Limerick Generating Station, Units 1 and 2
Facility Operating License Nos. NPF-39 and NPF-85
NRC Docket Nos. 50-352 and 50-353

Subject: Response to Request for Additional Information Concerning Relief
Requests Associated with the Second Inservice Inspection (ISI) Interval

**Response to Request for Additional Information
Regarding Relief Requests Associated With the
Second Inservice Inspection Interval**

Limerick Generating Station, Units 1 and 2

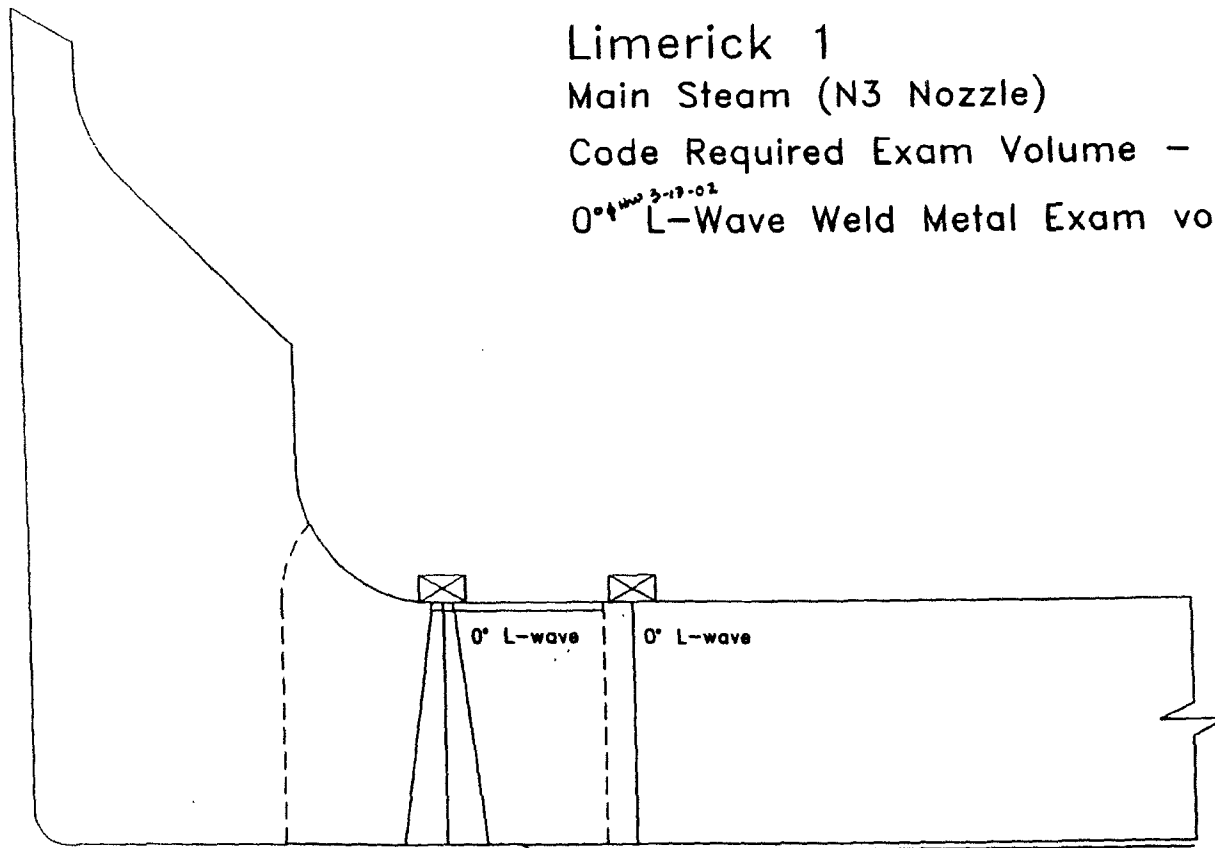
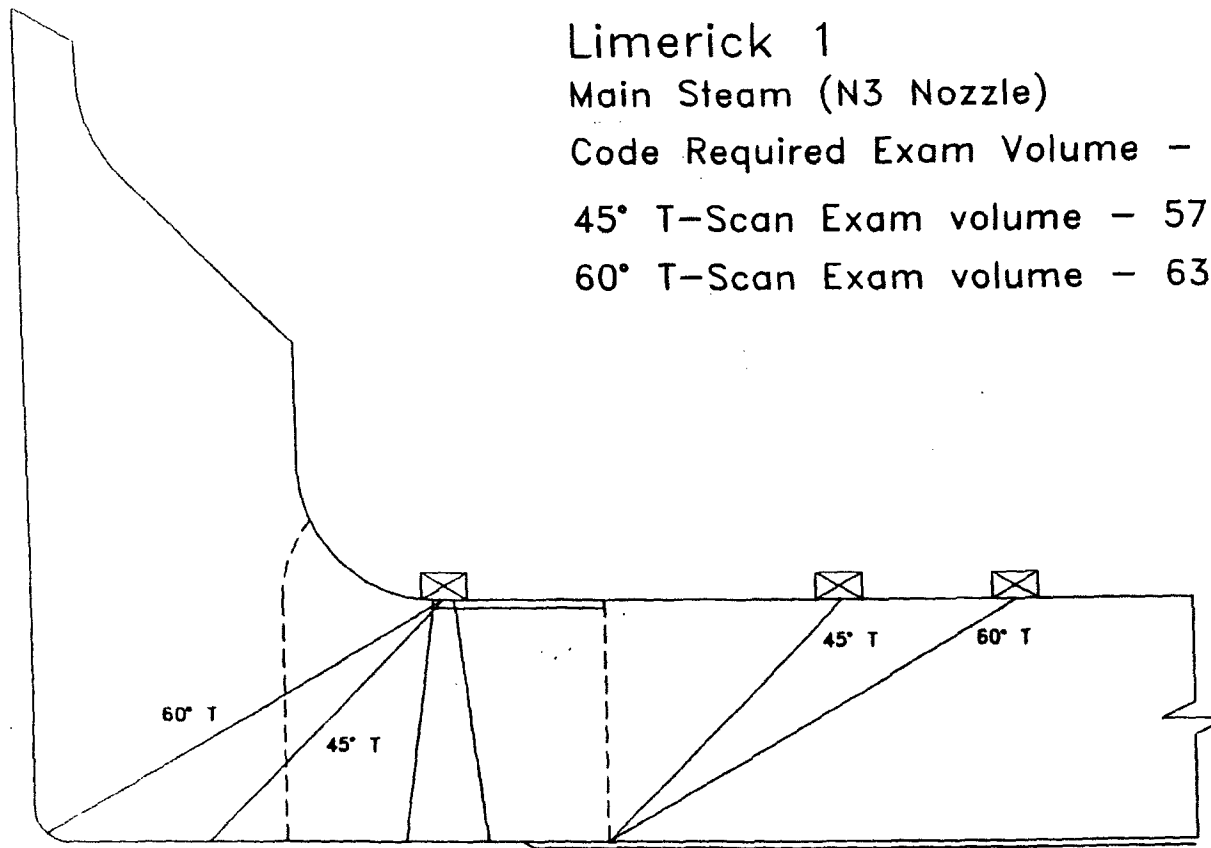
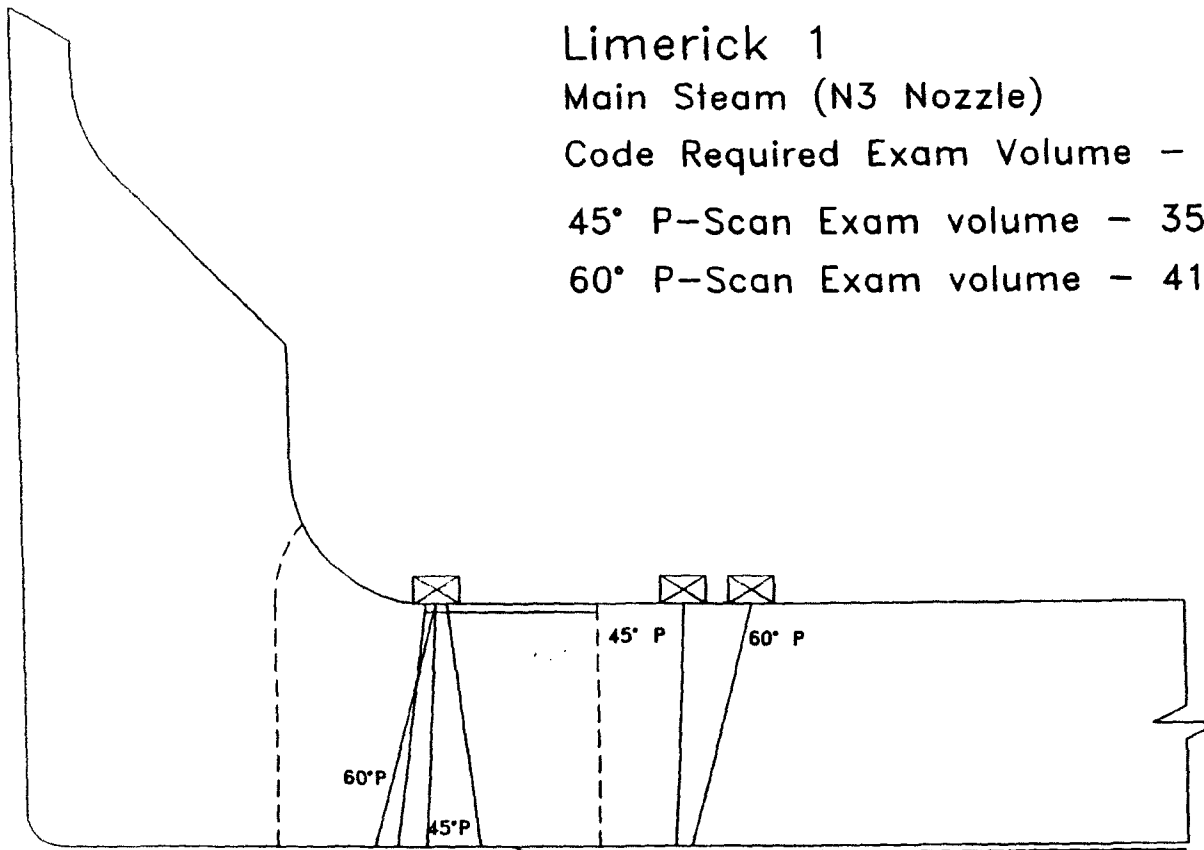
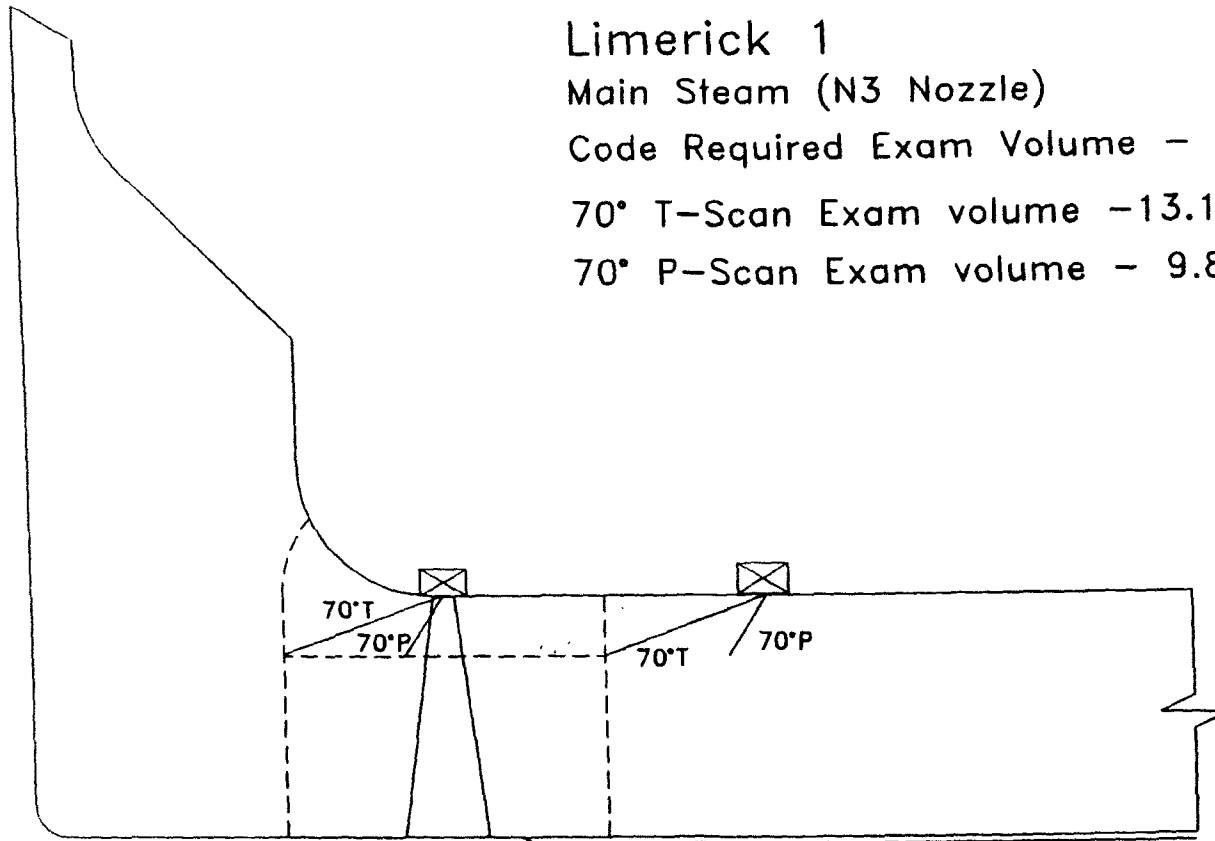
The completed examination was limited to 58.2% Code required coverage due to the design of the reactor vessel nozzle. The following coverage calculation sheet and the drawings contain the limitations. No unacceptable indications were noted. A system pressure test was also completed with no unacceptable indications observed.

N4 Feedwater

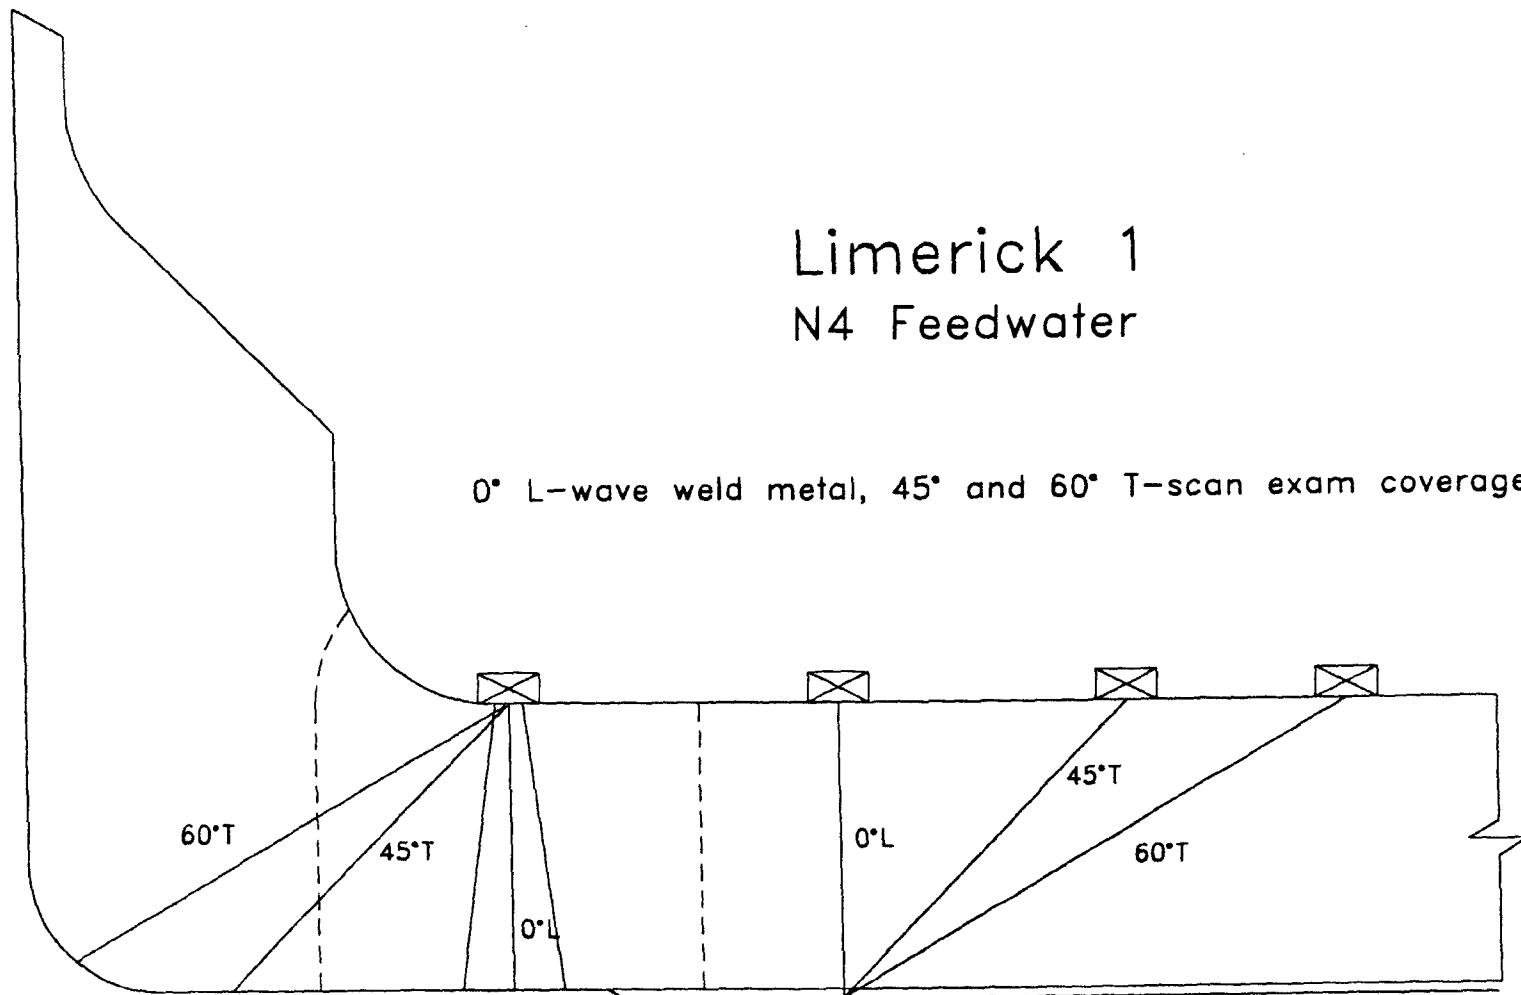
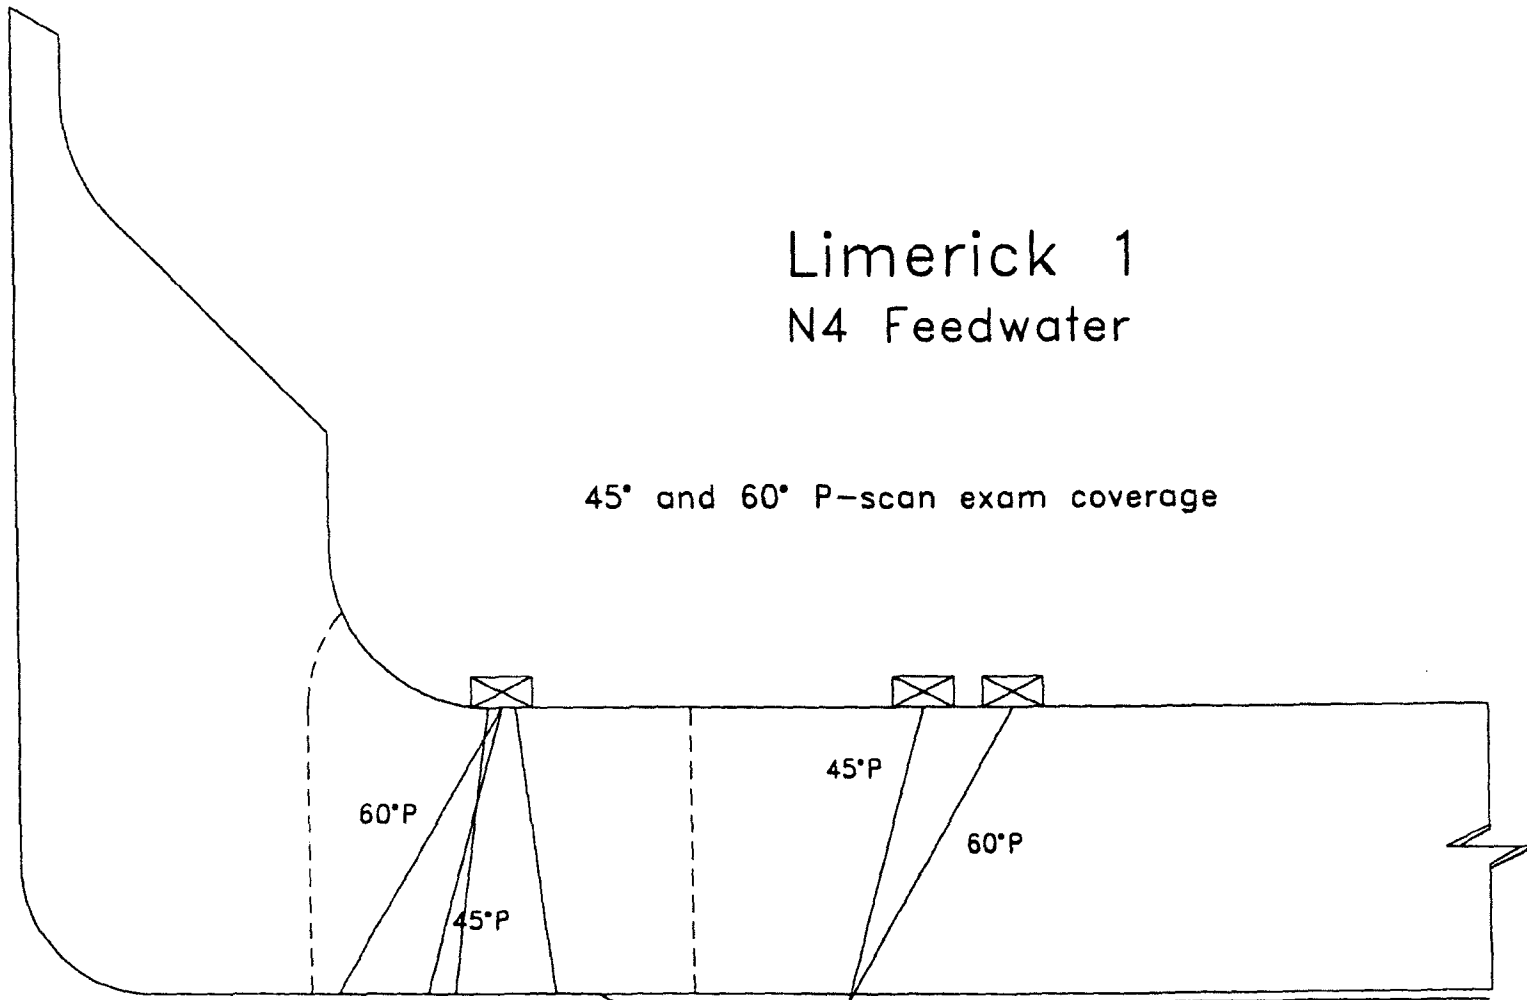
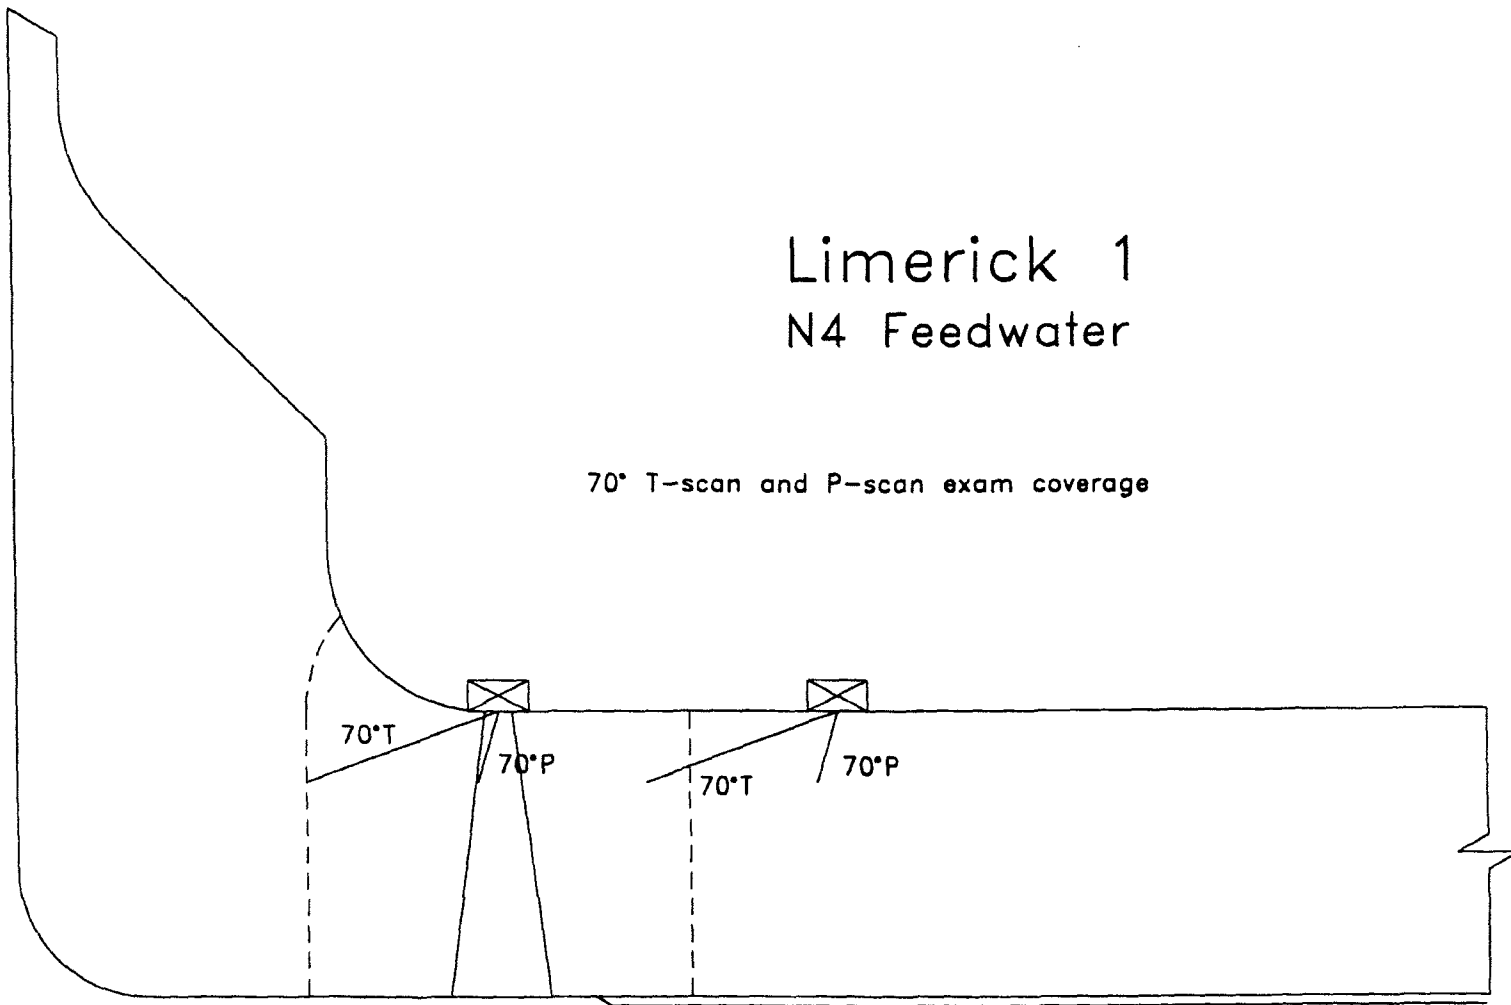
The completed examination was limited to 64.6% Code required coverage due to the design of the reactor vessel nozzle. The following coverage calculation sheet and the drawings contain the limitations. No unacceptable indications were noted. A system pressure test was also completed with no unacceptable indications observed.
